Avon Advisory Planning Commission Meeting
Monday, February 23, 2026 at 6:30 pm
at Avon Town Hall

Planning & Building Department Staff Report

Exhibit C – Planning TAC Letter (Page 1 of 4)

Exhibit D – Proposed Landscape Plan

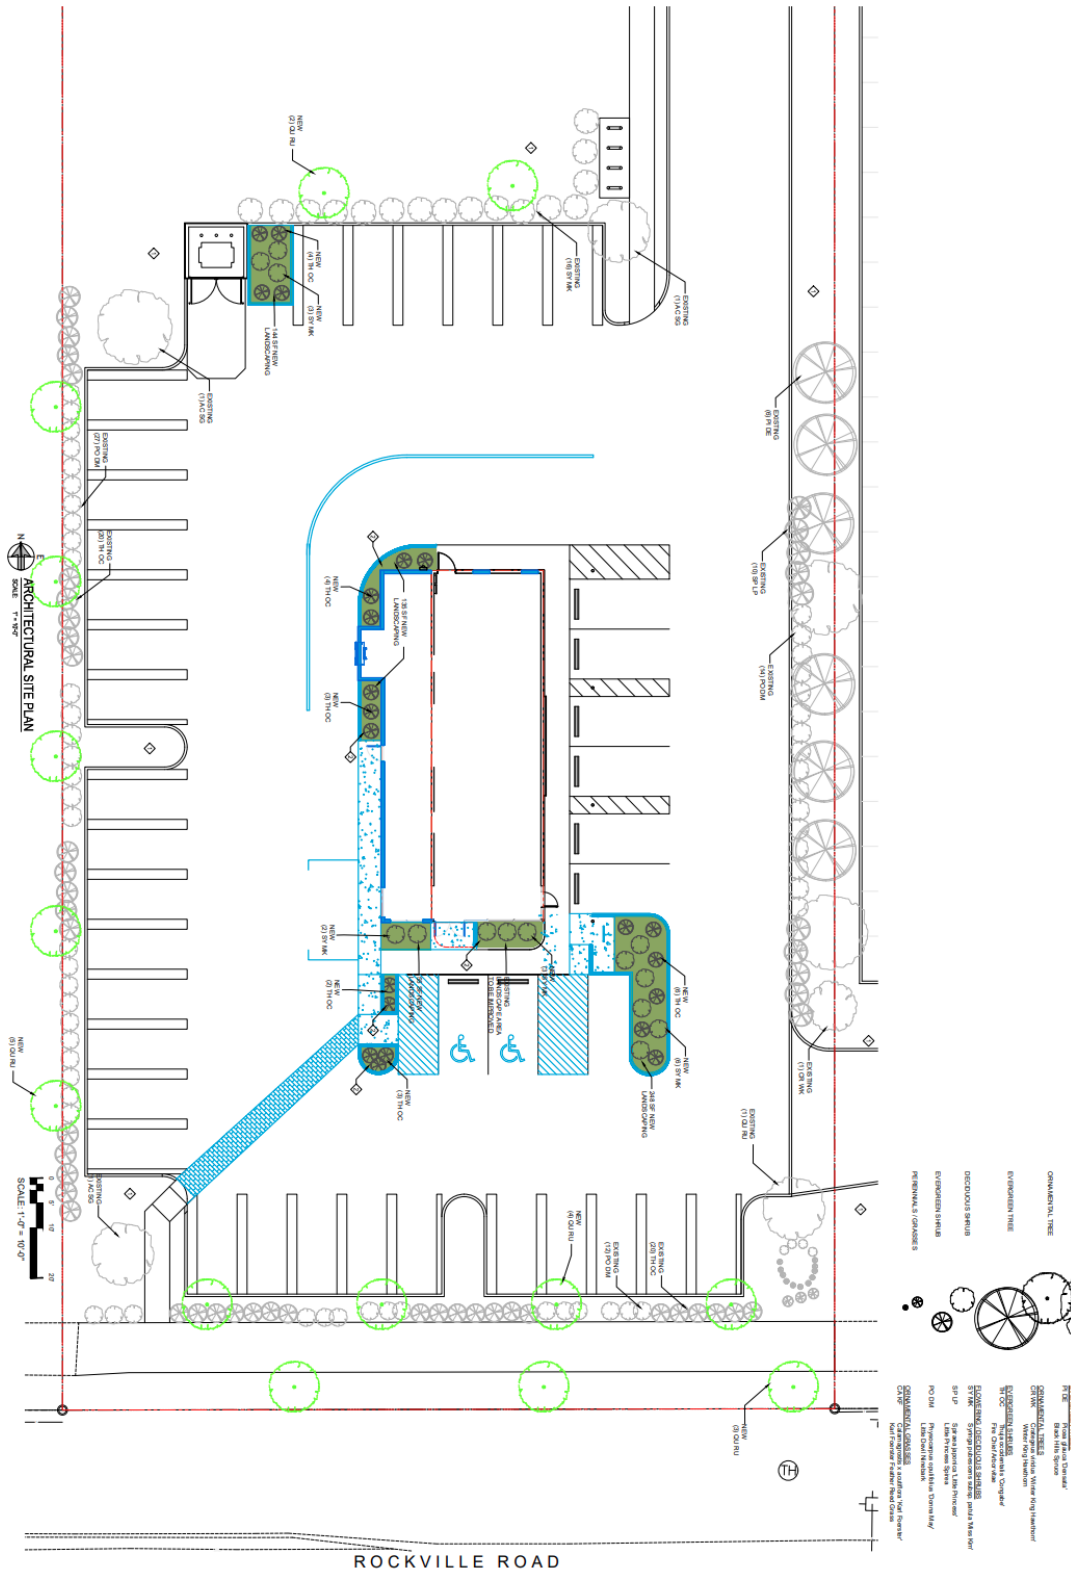
The revised landscape plan, submitted subsequent to the Technical Advisory Committee (TAC) meeting, addresses staff comments requesting additional tree plantings along the site's U.S. Highway 36 frontage and the west perimeter of the parking lot, terminal islands on each end of the parking row adjacent to the south façade, and additional foundation planting areas. It appears that additional landscaping should be included north of the trash enclosure to screen it from Harvest Landing Drive as required by UDO 5.1(H)(1).

Exhibit E – Existing & Proposed Building Elevations (South & North)

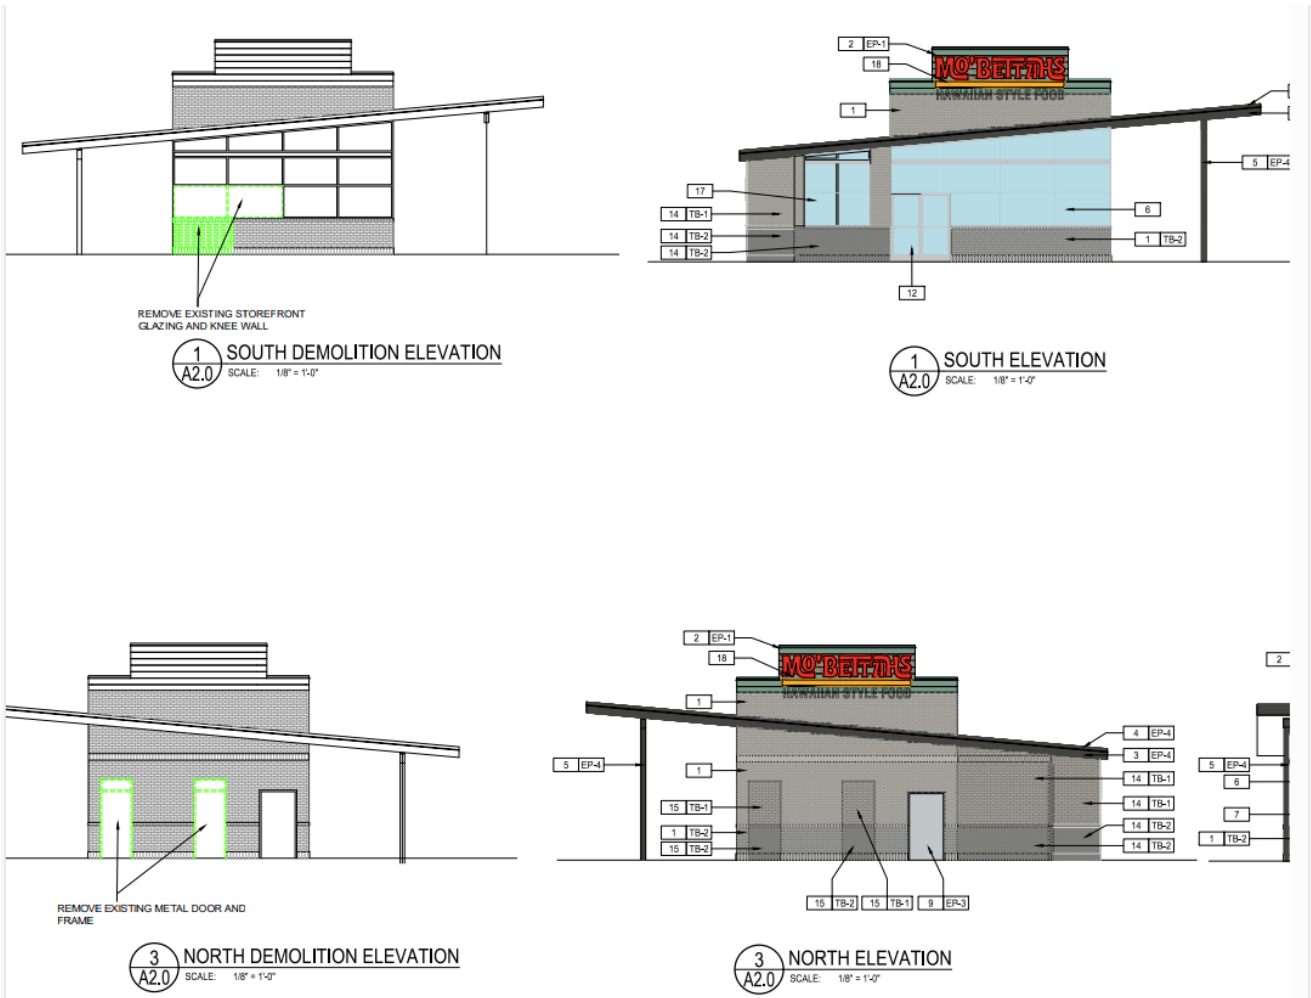
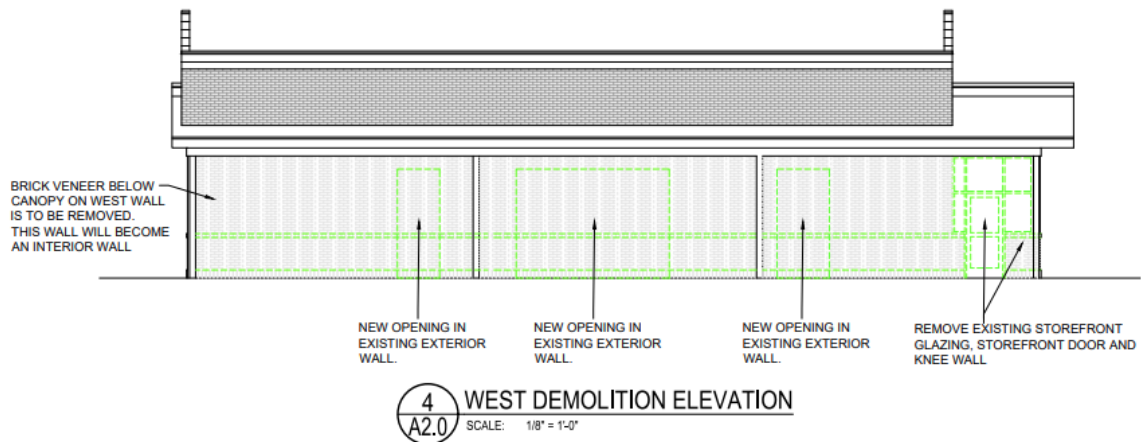
The revised building elevations submitted subsequent to TAC review appear to meet both the general architectural standards of UDO 7.10 as well as the additional U.S. Highway 36 overlay requirements found in UDO 2.10(O), except for the waiver for use of "thin brick", which is addressed below.

Petitioner’s response: “the proposed thin brick will match the existing thin brick.”
